HISTORIC AND DESIGN REVIEW COMMISSION

HDRC CASE NO: 2020-153
ADDRESS: 226 CAMARGO
LEGAL DESCRIPTION: NCB 924 BLK 5 LOT N 109.77 FT OF W 50 FT & S 46 FT OF W 44 FT OF 6
ZONING: RM-4, H
CITY COUNCIL DIST.: 1
DISTRICT: Lavaca Historic District
APPLICANT: MEVT HOLDINGS LLC
OWNER: MEVT HOLDINGS LLC
TYPE OF WORK: Front yard fence, landscaping, brick sidewalk, porch repair
APPLICATION RECEIVED: March 17, 2020
60-DAY REVIEW: Not applicable due to City Council Emergency Orders
CASE MANAGER: Huy Pham

sheet title:
Preliminary Plan

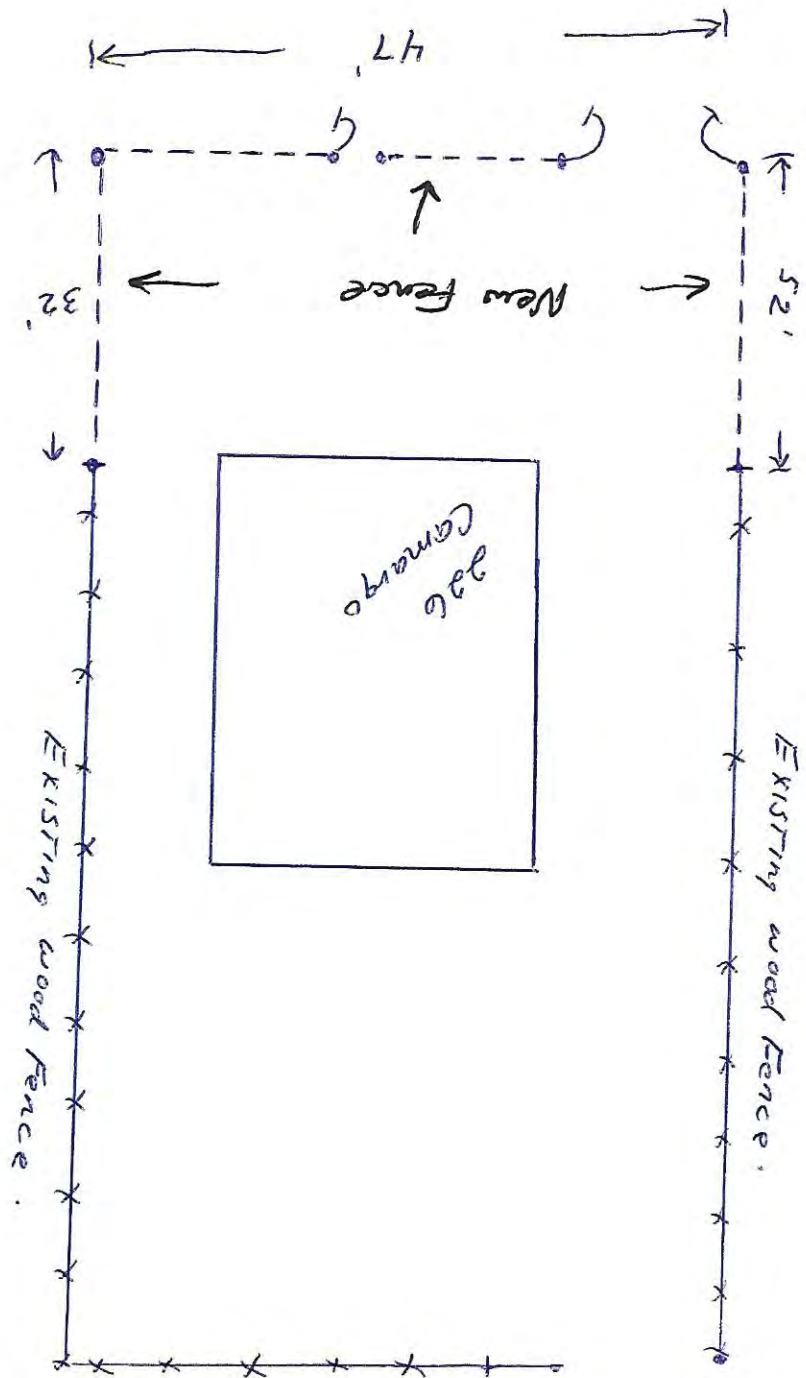
- i. LANDSCAPE – The applicant has proposed to replace portions of the natural front lawn with multiple plant beds, areas of low ground cover, and small portion of flagstone pavers. Staff finds that the front yard landscaping plan is consistent with the Guidelines for Site Elements 7.A.ii through iv.

Fence Design.

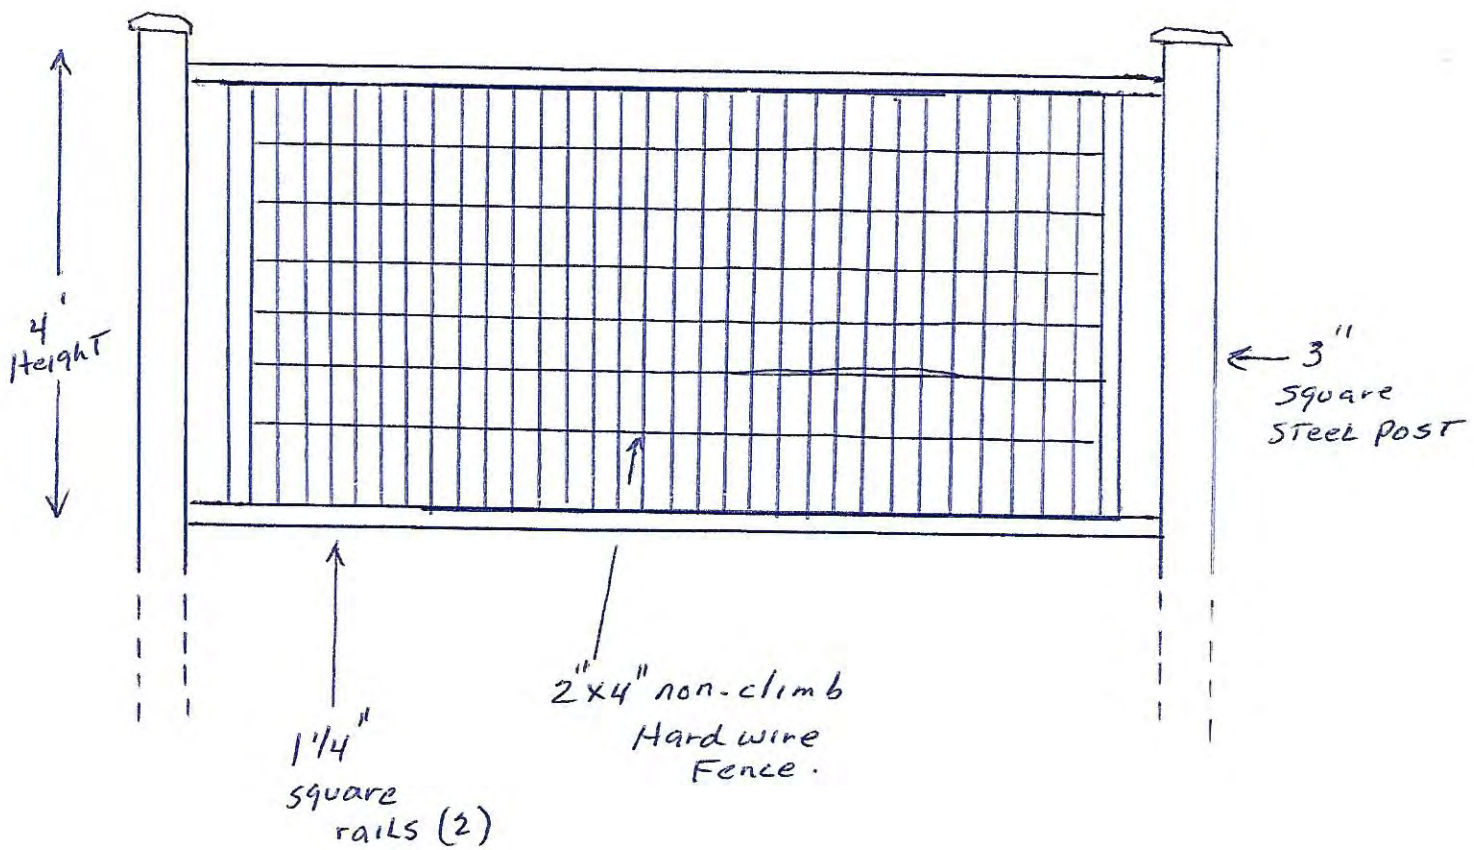
- f. FENCE DESIGN – The proposed fence features a metal-framed cattle panel design as depicted in the measured drawing. Per the Guidelines for Site Elements 2.B.i., new fences and walls should appear similar to those used historically within the district in terms of their scale, transparency, and character, and respond to the design and materials of the main structure. Staff finds that a wood framed cattle panel fence are found in the district at historic structures and would be more appropriate than a metal framed fence.

- h. FENCE HEIGHT – The applicant has proposed to install a fence with a height of 4-feet at its tallest point at the pedestrian and driveway gate. Per the Guidelines for Site Elements 2.B.iii., applicants should limit the height of new fences and walls within the front yard to a maximum of four feet. Staff finds that the proposed height of 4-feet is appropriate and relates to existing neighboring front yard fences. If the driveway gate is relocated behind the front façade plane of the house, it may feature a maximum height of 6-feet.

- i. No Certificate of Appropriateness will be issued until work without approval has been corrected or approved, including but not limited to restoring the original design of the front porch columns.
- ii. That no portion of the rear yard fence exceeds 6 feet in height nor encroach past the front façade plane.
- iii. That the front yard fence should turn at the driveway, instead of spanning across the front, and meet at the front corner of the front façade. The driveway gate should be set behind the front façade plan of the house and be incorporated into the privacy fence design – or removed from the fence plan.
- iv. That no portion of the front yard fence exceeds 4 feet in height, and if the driveway gate is relocated behind the front façade plane of the house, it may feature a maximum height of 6-feet.
